REQUEST FOR PLANNING COMMISSION ACTION

Meeting Date:	February 2, 2023						
Item Name:	SITE PLAN & DESIGN REVIEW - Scooters Coffee - submitted by Abby Heli						
Originating Department:	Community Development						
Presented by:	Ethan Nelson						
Previous Commission Action (if any):							
Item Type (X only one):	<table><tr><td>Consent</td><td>☐</td><td>Regular Session</td><td>☒</td><td>Discussion Session</td><td>☐</td></tr></table>	Consent	☐	Regular Session	☒	Discussion Session	☐
Consent	☐	Regular Session	☒	Discussion Session	☐

Provide recommendation to the City Council regarding Site Plan & Design Review application for the proposed Scooters Coffee for the property located at 660 Marketplace Drive

SITE DIMENSIONAL & PAVING PLAN

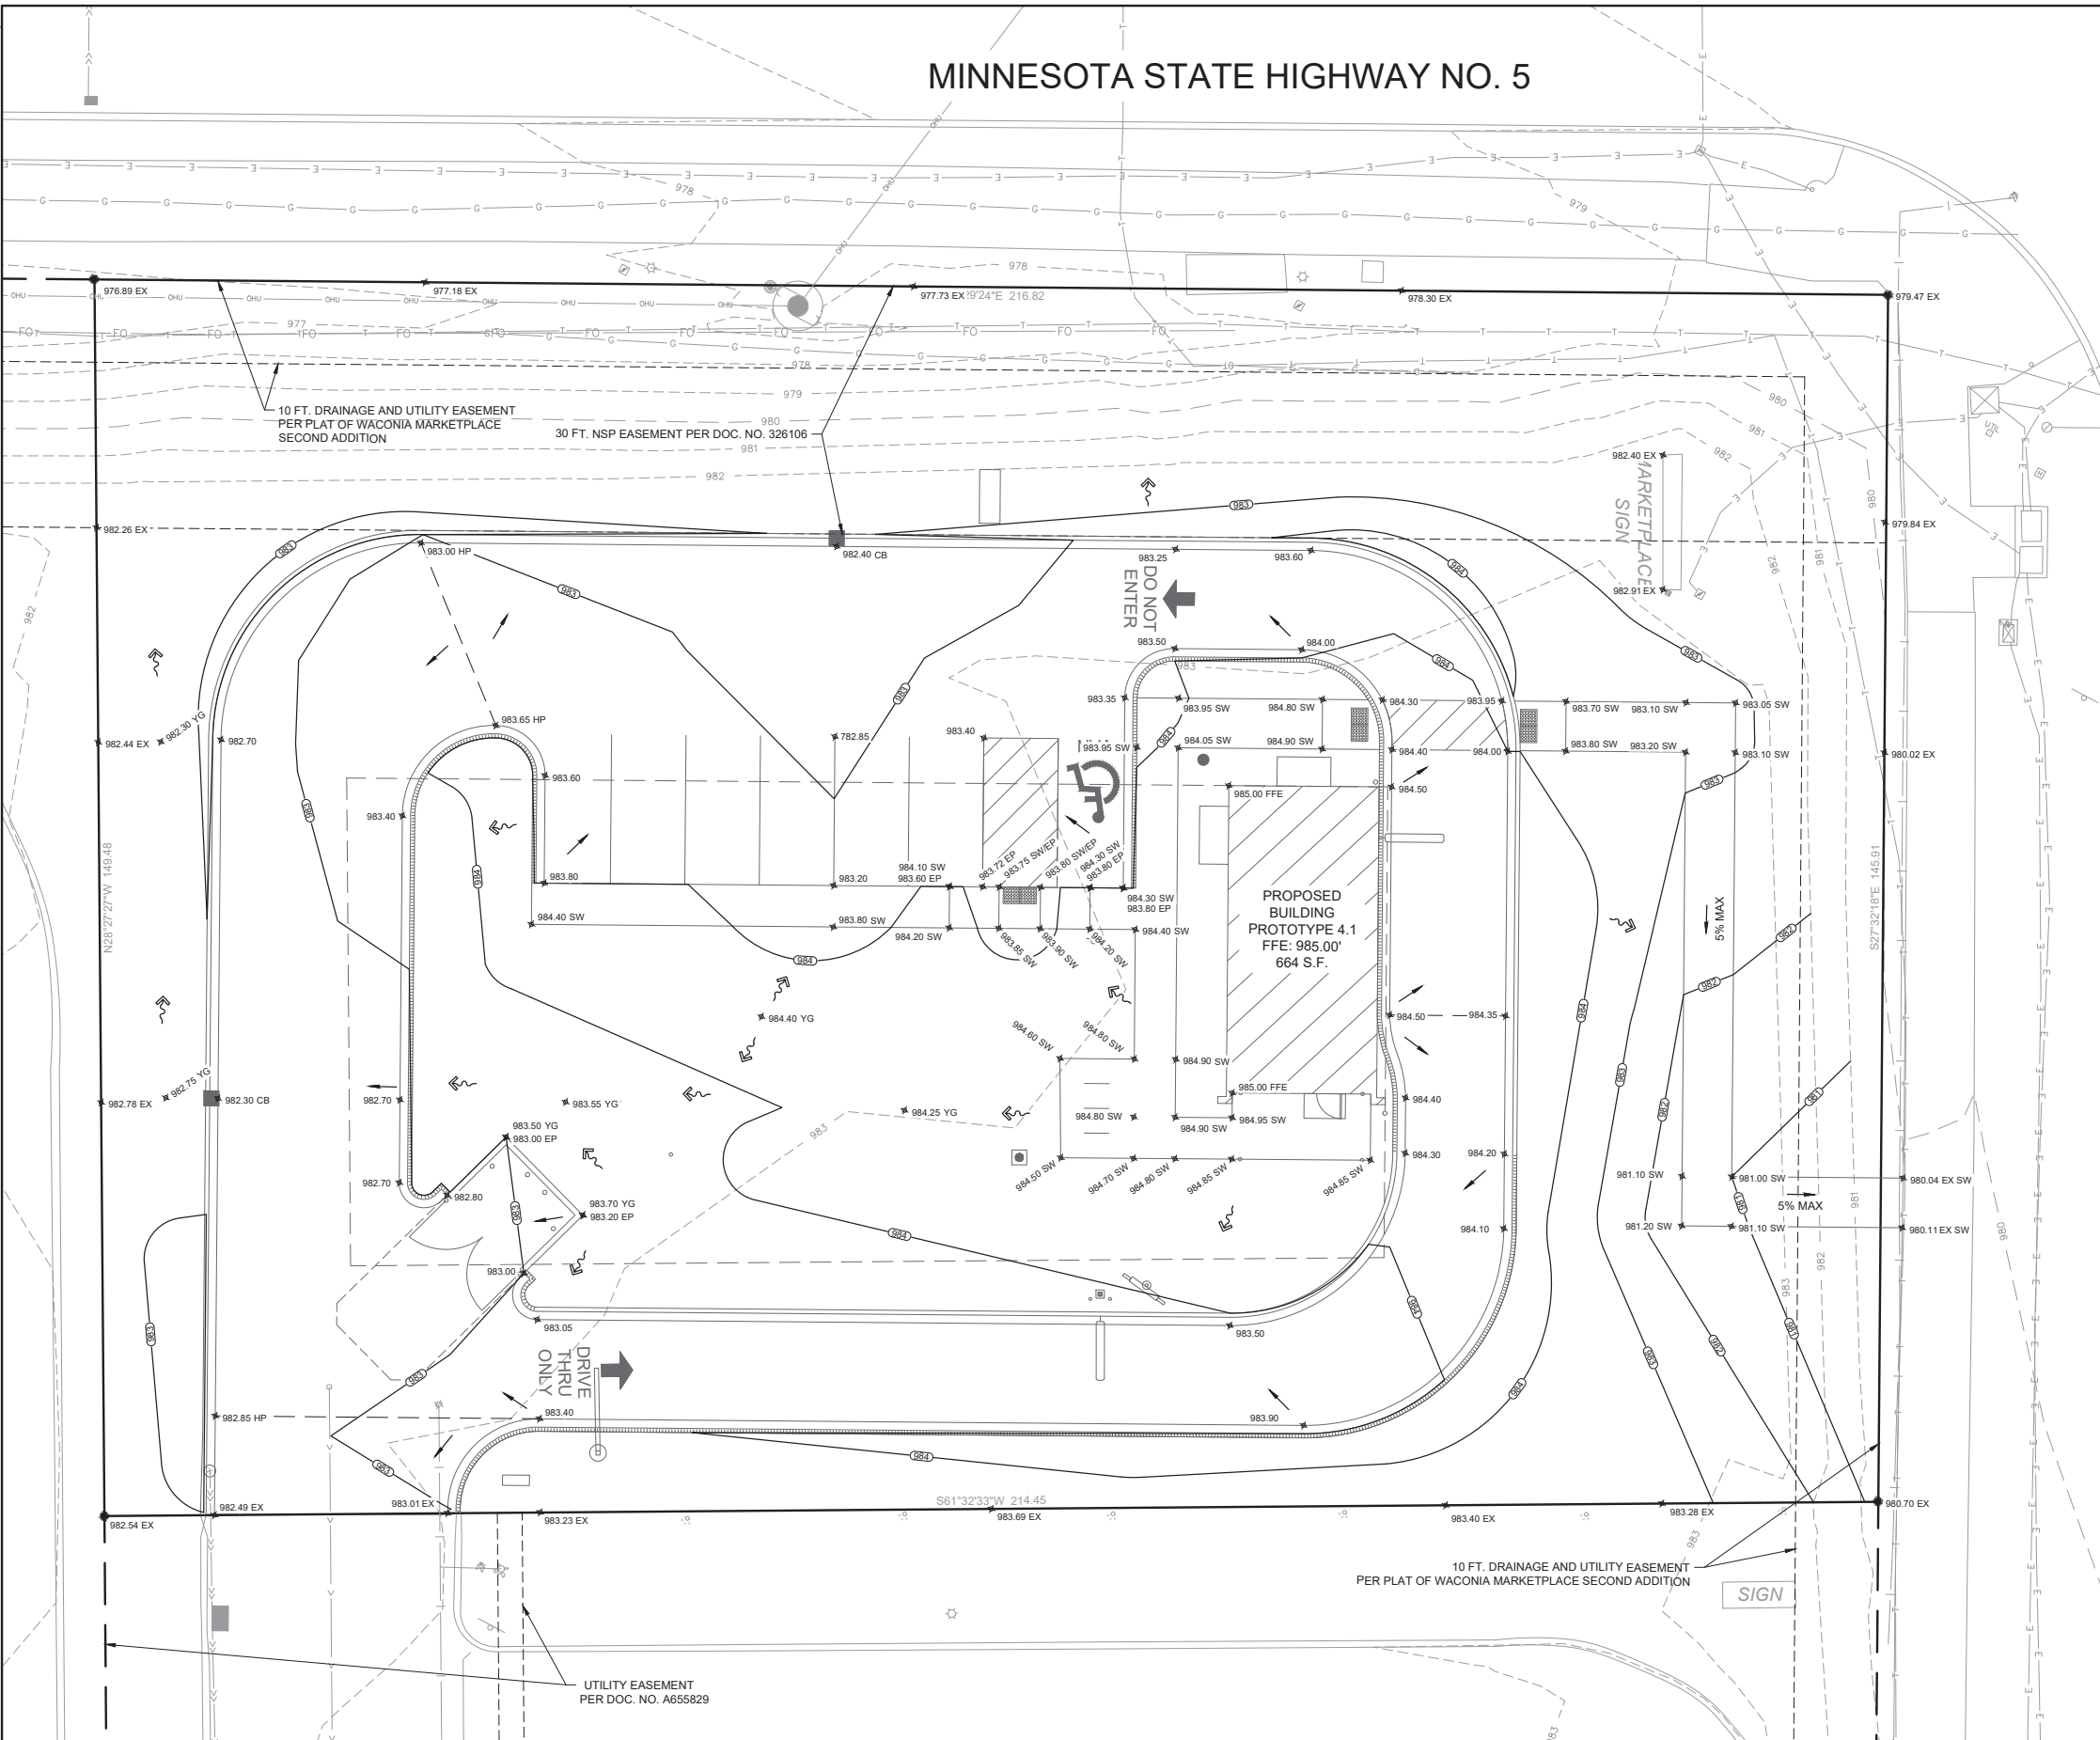
employees only. The site plan only lists a single ADA sign for the handicapped parking space. Staff recommends the Planning Commission clarify this item with the applicant.

City Code allows drive thru-services provided the use has sufficient stacking space to accommodate the number of vehicles which can be served during a 15 minute period. The applicant is proposing one drive-thru lane and contemplates a maximum stacking of 10 vehicles without spilling into the access road. The Planning Commission may wish to consider discussing this stacking space with the applicant to determine if this is a sufficient amount for a 15 minute period.

LANDSCAPE PLAN

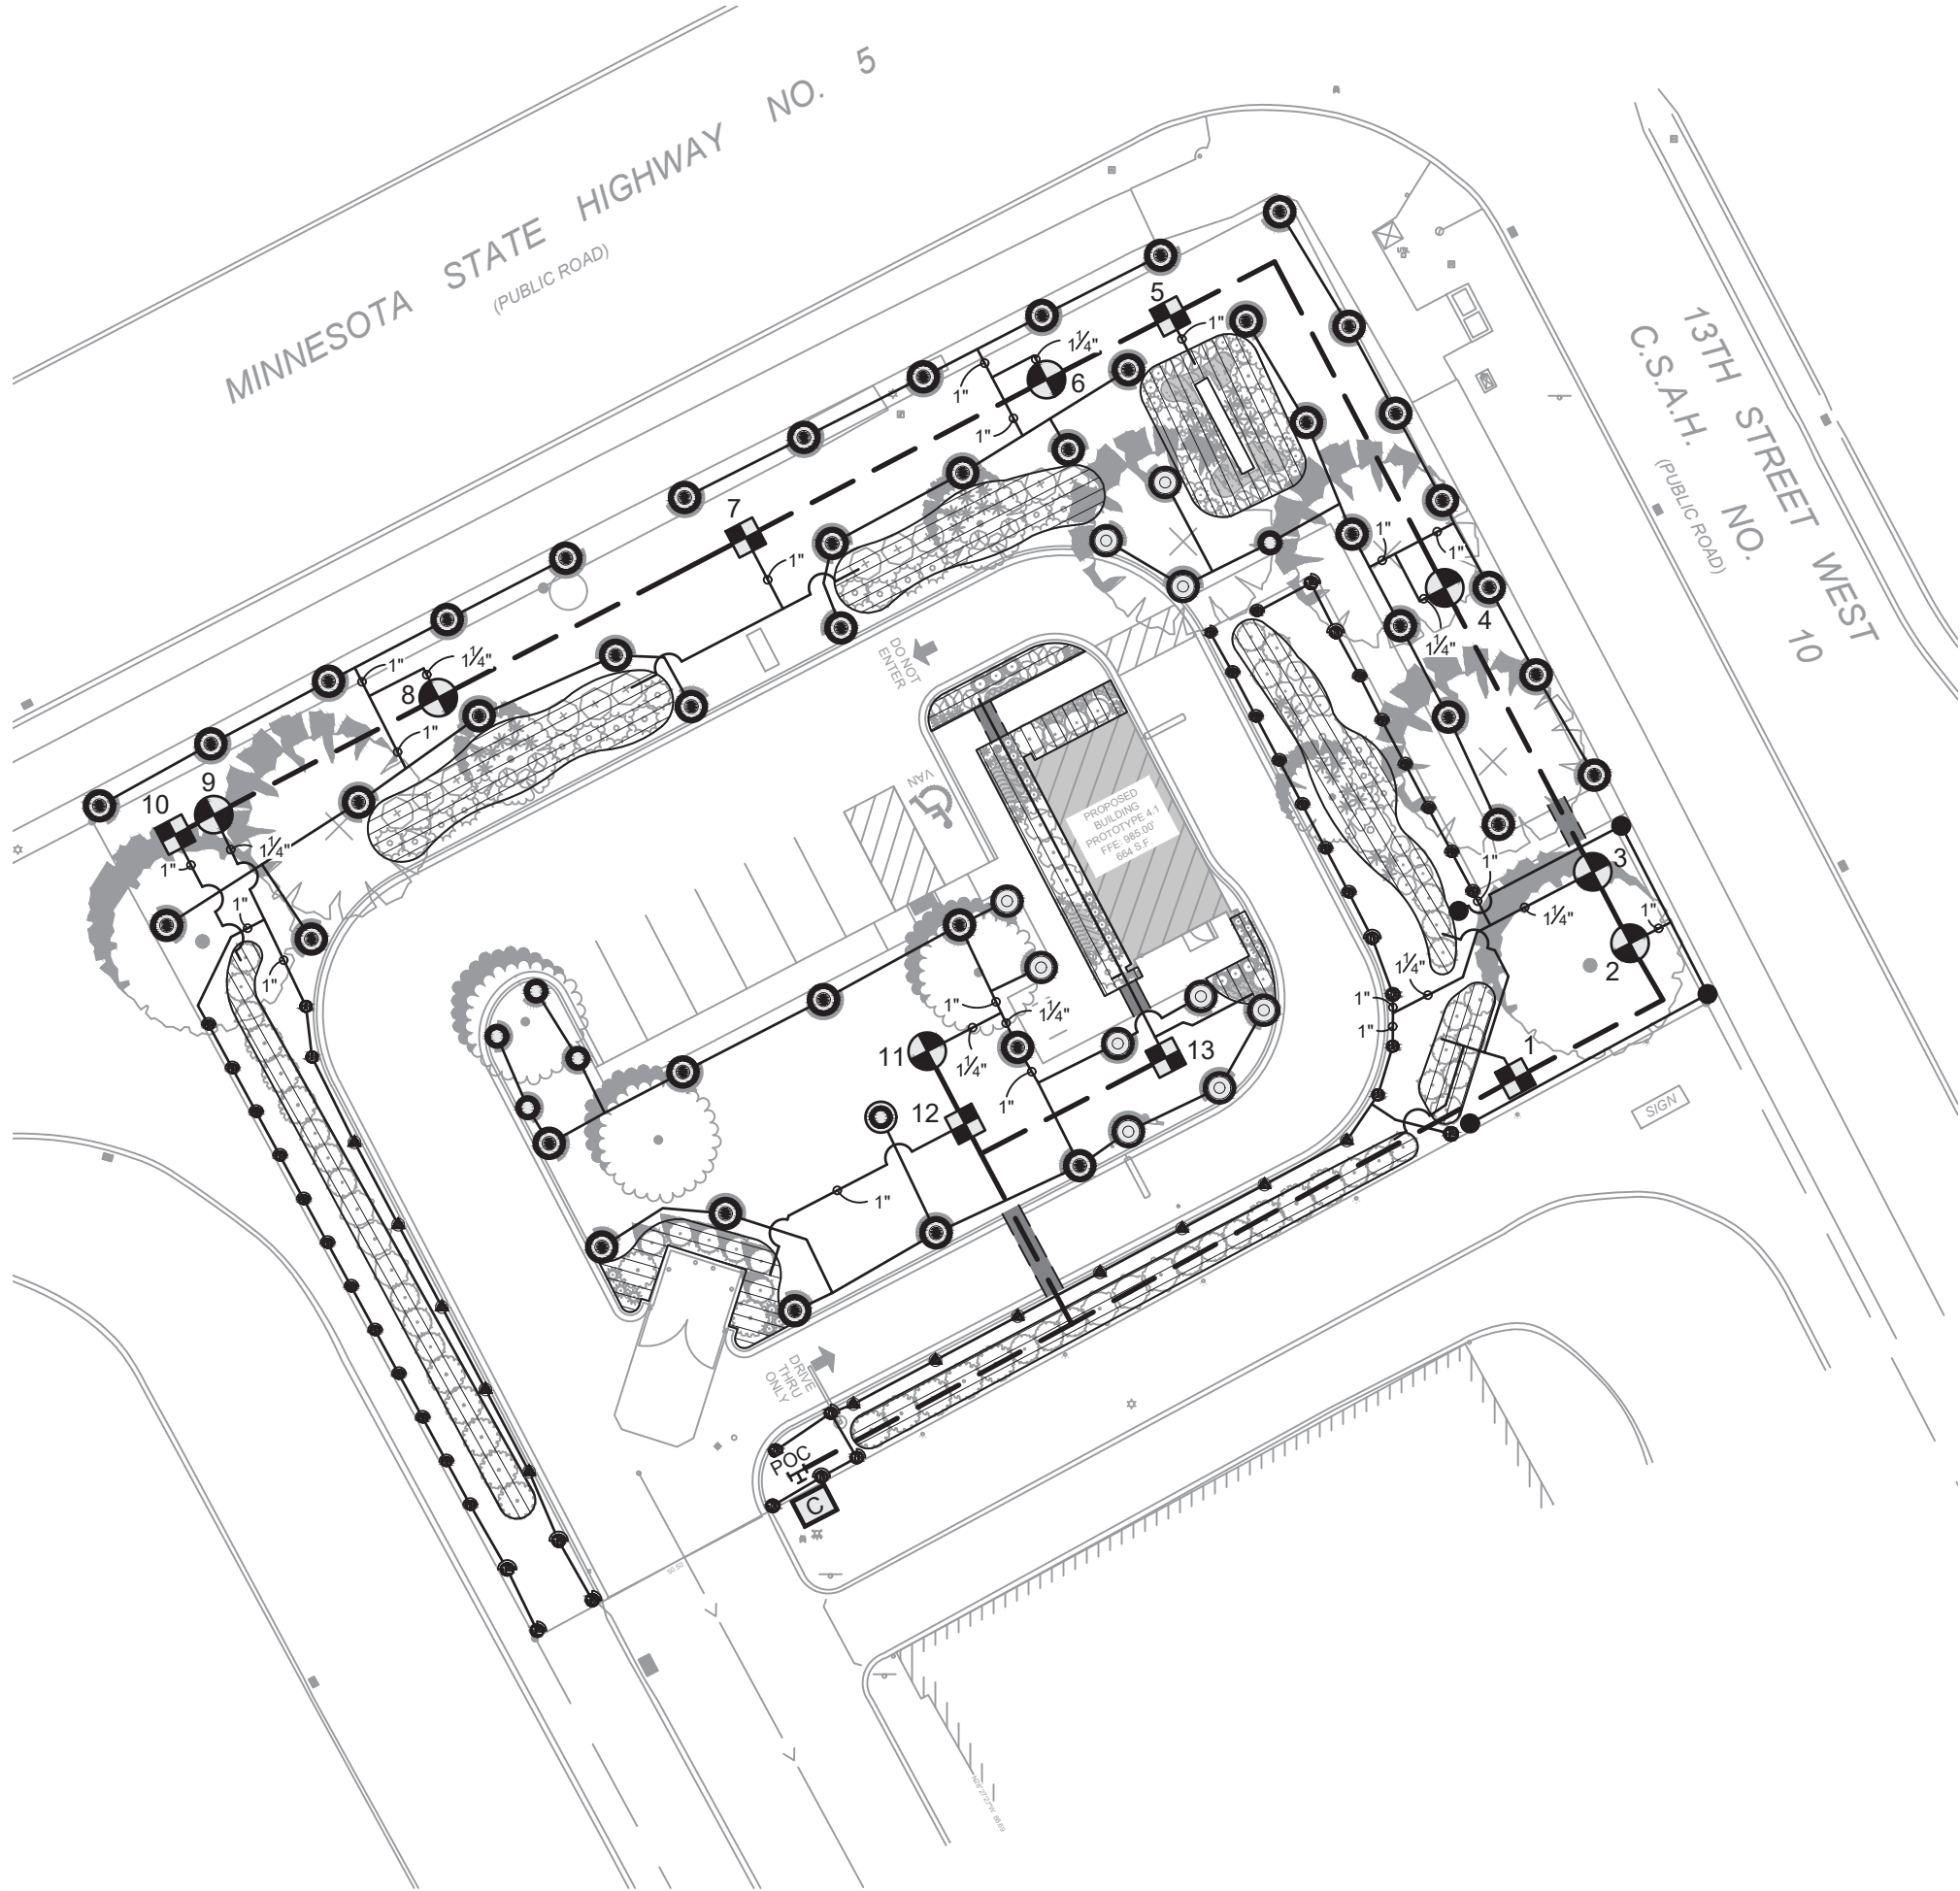
The gross building floor area of the proposed addition is 664 sq. ft. and the total site perimeter is 726.66 lineal feet. The applicant is proposing 12 trees that meet the minimum size requirements. City Code requires 15 trees, therefore the applicant shall be required to add an additional 3 trees meeting City minimum size standards.

The applicant shall plant an additional 6 trees that meet the standard indicated above.

TITLE:
TRASH
ENCLOSURE
ELEVATIONS &
DETAILS

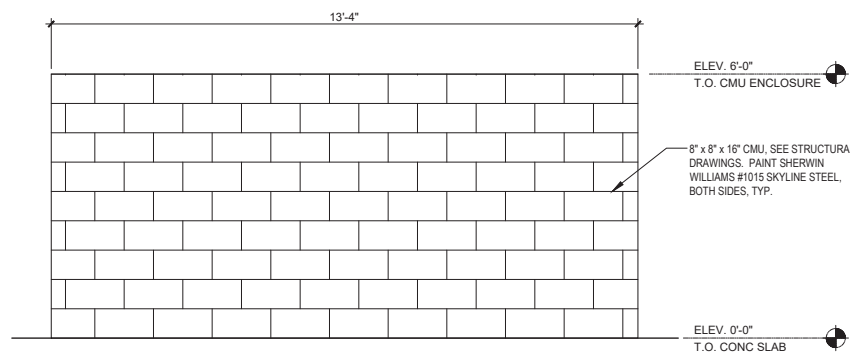
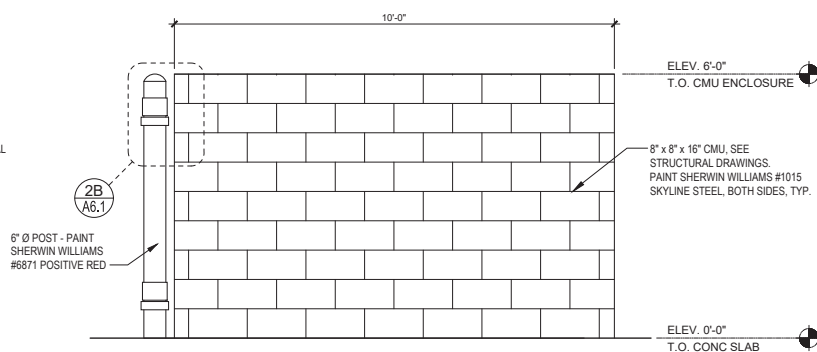
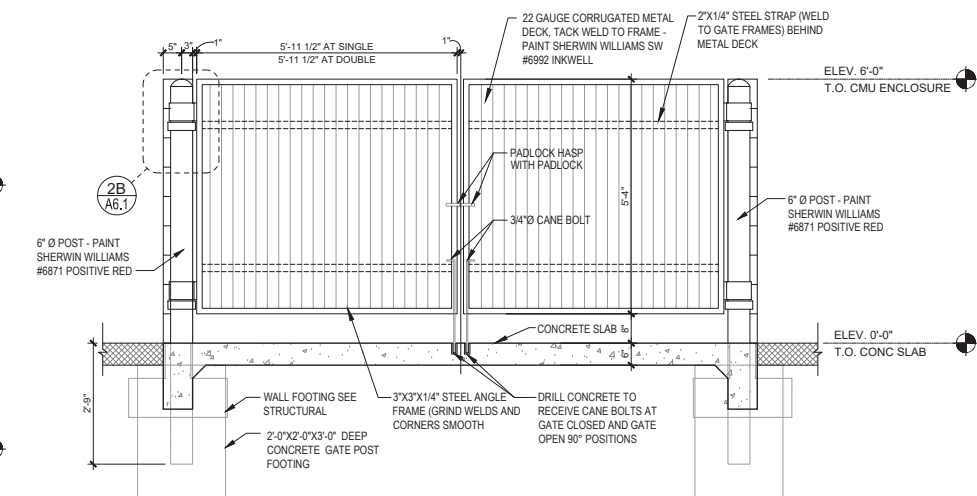
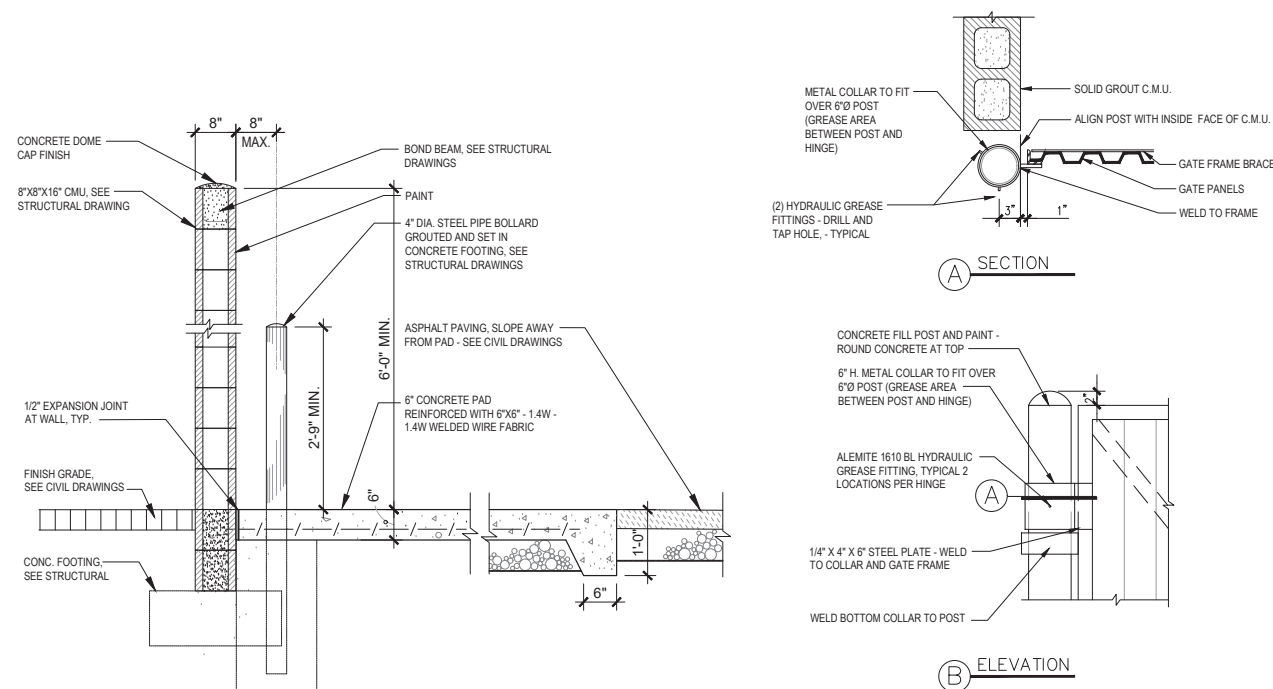
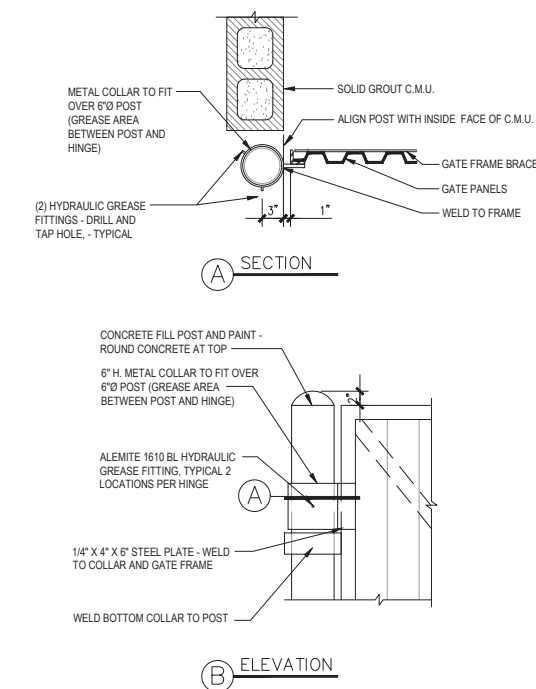
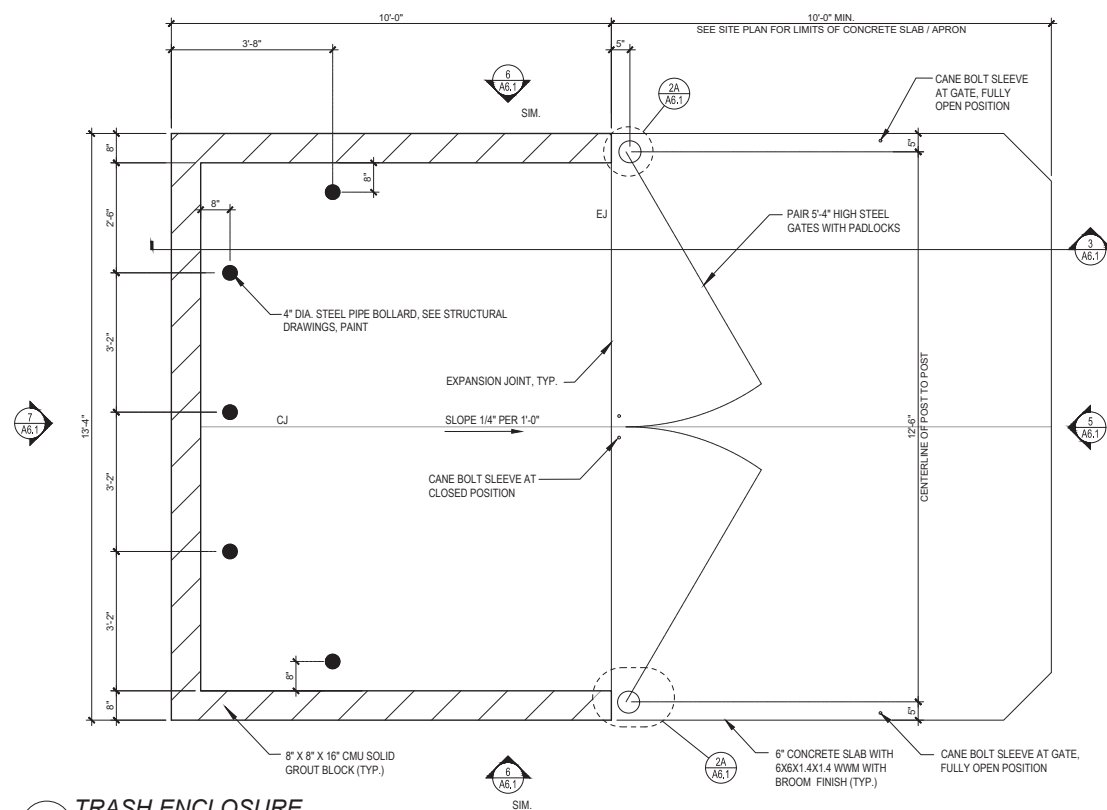
The plans show an exterior trash enclosure on the south-west side of the property. The elevations shown on the plan page A6.1 appear to propose material inconsistent with the principal structure as noted in the code language above. The applicant shall ensure all materials match with the principal structure consistent with code requirements upon building permit review. The Planning Commission may wish to discuss this item with the applicant.
